ADMINISTRATIVE AMENDMENT

PROJECT NUMBER: PR-2021-006307

Application Number: SI-2022-00327

MARKANA MODESTO PHASE II
5051 JOURNAL CENTER BLVD. STE. 500
ALBUQUERQUE, NM 87109
LEGACY DEVELOPMENT AND MANAGEMENT, LLC

LANDSCAPE PLAN

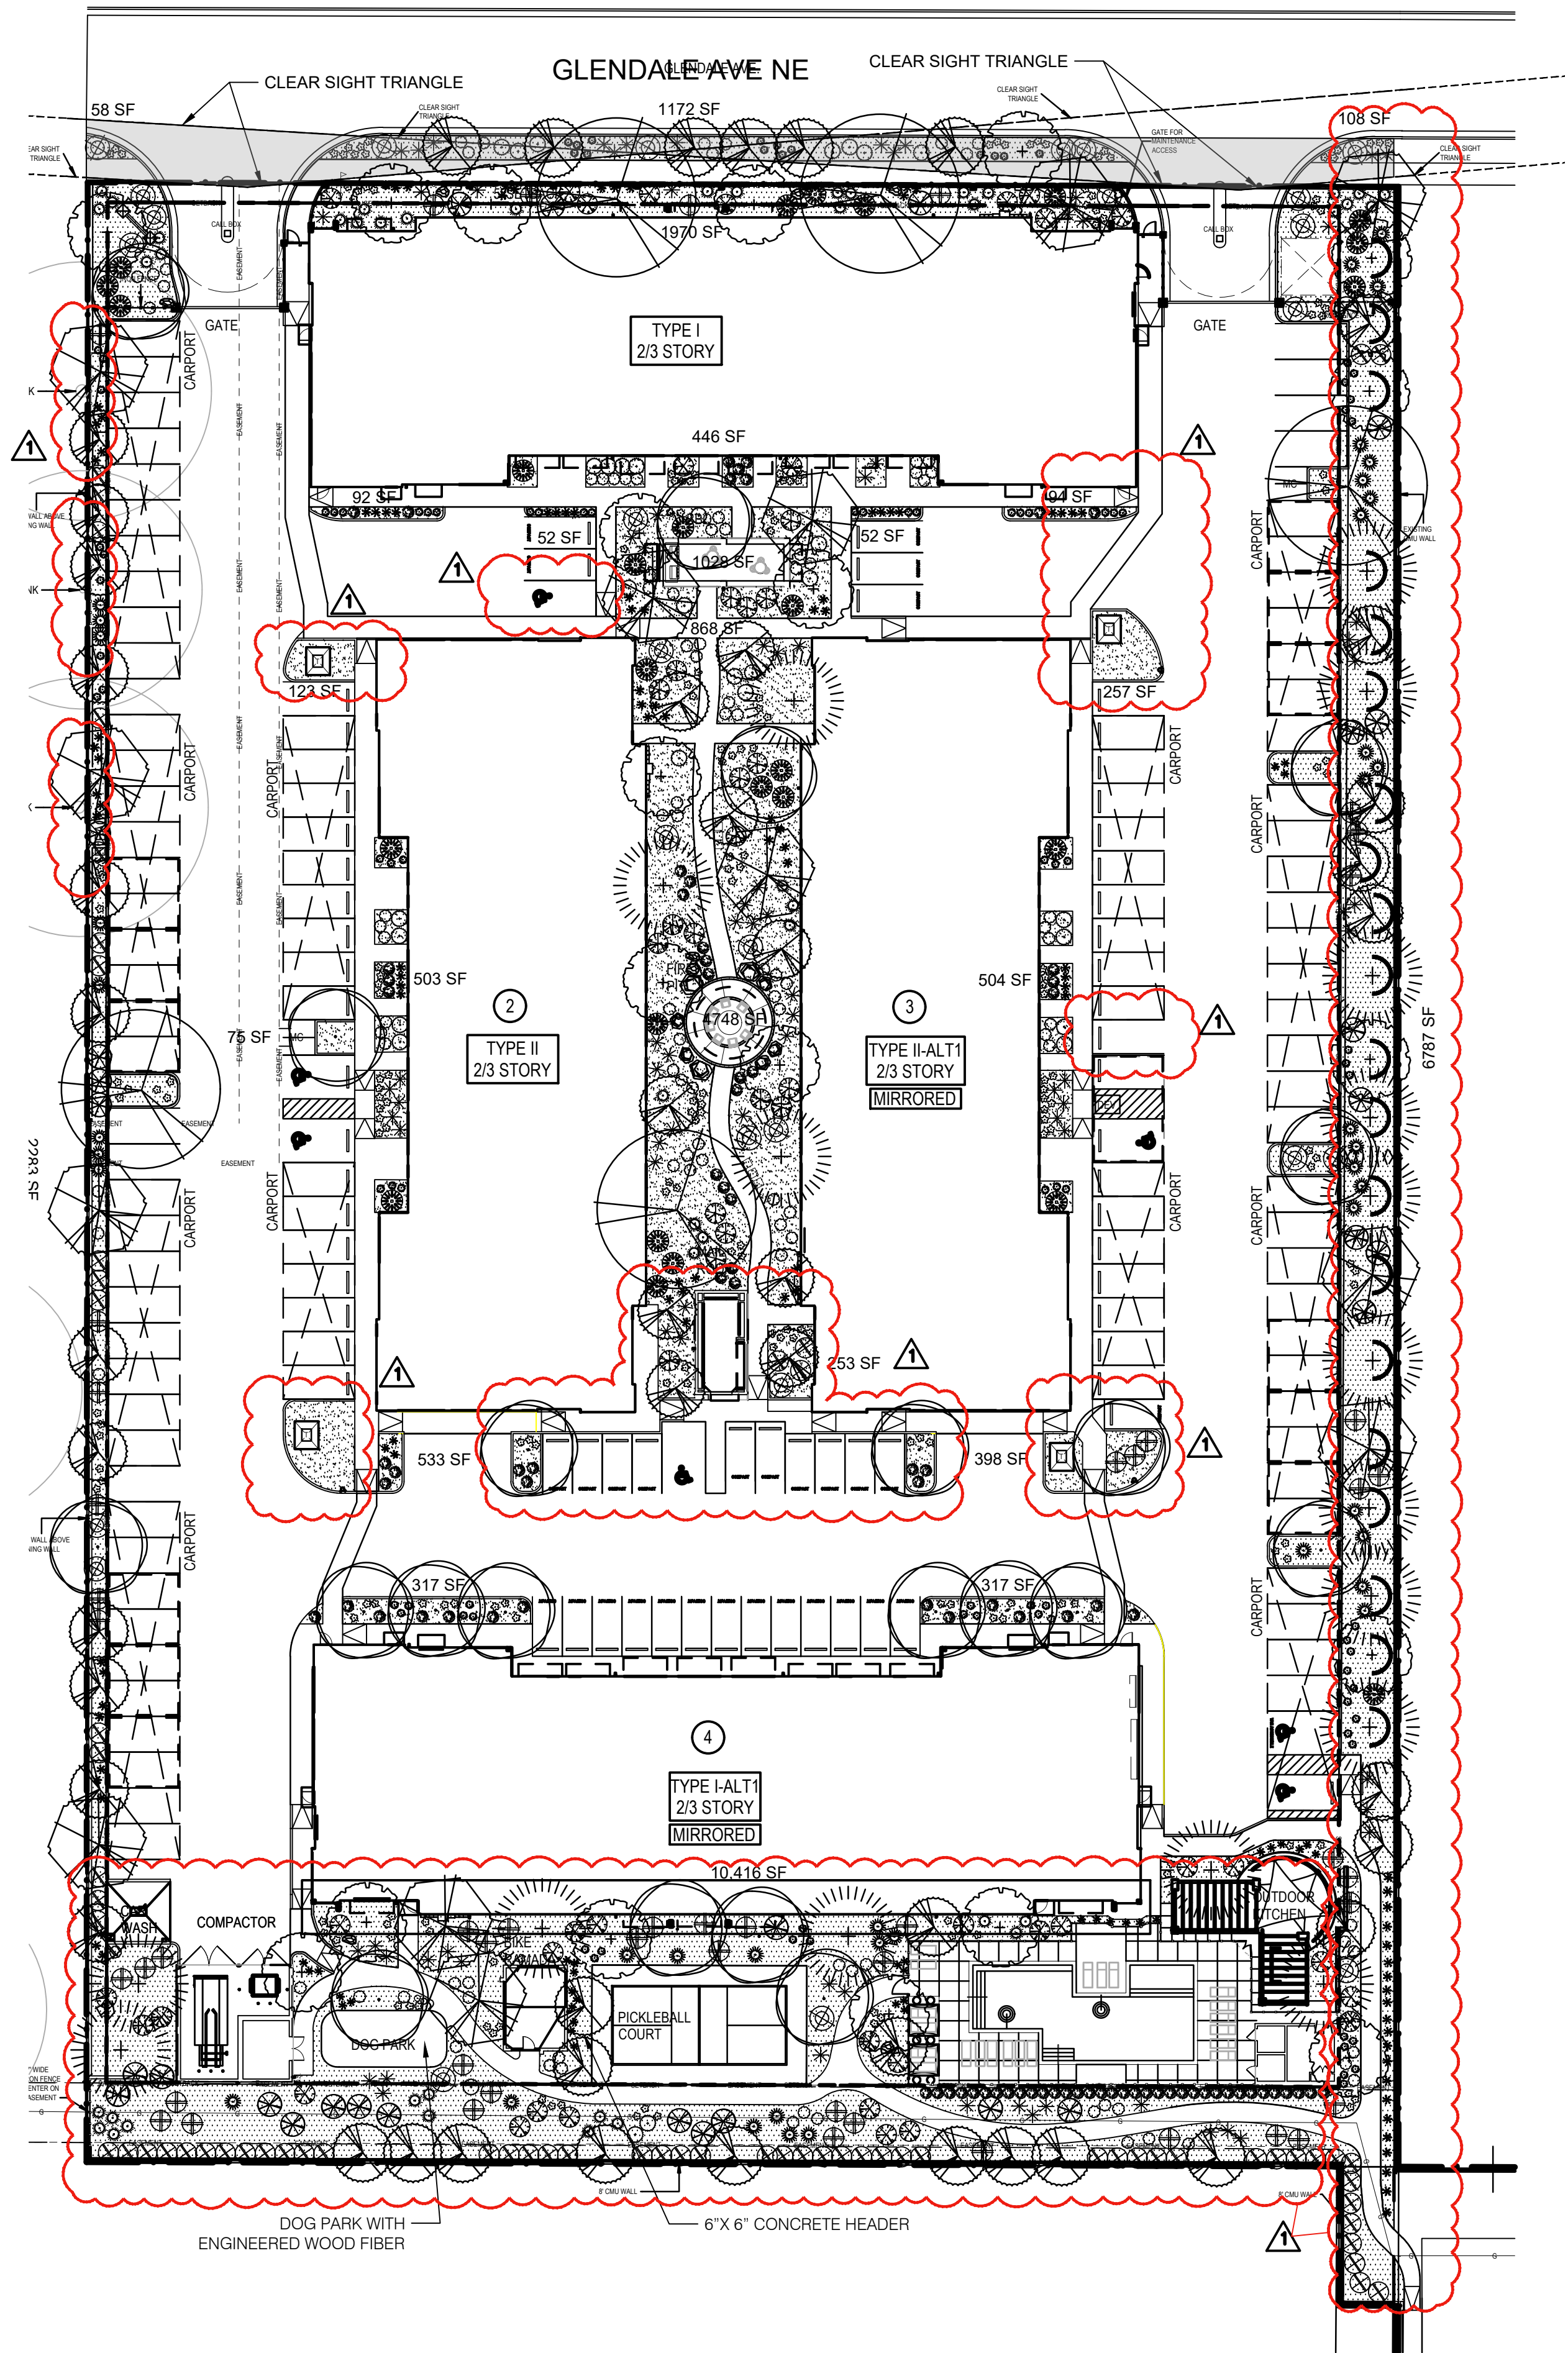
NO.	DATE	DESCRIPTION
1	11/30/23	ADDITION OF TREE PLANTER WALLS, ADDITION OF PICKLE BALL COURT AND REARRANGING PLANT MATERIALS, REMOVAL OF TURF GRASS AREA, ADJUSTMENT OF PLANT MATERIALS, AND PLANTING BEDS PER PNM DIRECTION
